TECHNICAL SERVICE BULLETIN

REF.: BODY
NO.: BO95-003
DATE: JUNE 9, 1995
MODEL: GB (AVALON)

SLOW RETURN OF INSIDE DOOR HANDLES

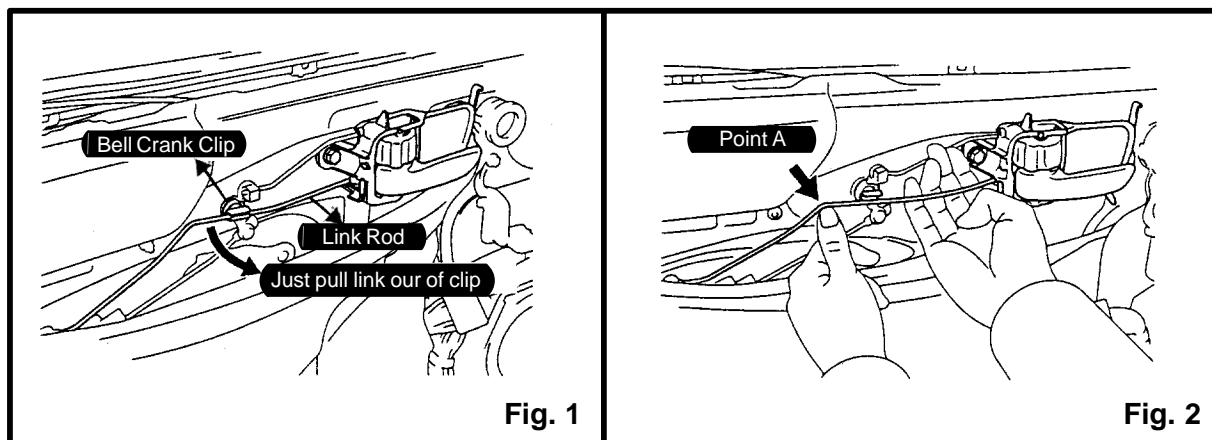
The inside door handle link rods have been modified to increase the return speed of the inside door handles.

1. Remove door trim panel.
2. Remove inside door handle link rod from bellcrank clip (Fig. 1).

3. Support the link rod by positioning the fingers of your right hand behind the link rod just forward of the bell crank clip to act like spacers. Then push outboard at the bend in the link rod (point A) to straighten the rod with your other hand (Fig. 2).
4. Reconnect the link rod to the bell crank clip and check the return speed of inside door handle. If return speed is still too slow, repeat steps 2-4 above.

NOTE: Excessive bending of the link rod may cause noisy inside door handle operation.

5. If inside door handle return speed and sound is acceptable, reinstall door trim.
6. Repeat procedure for other doors as necessary.
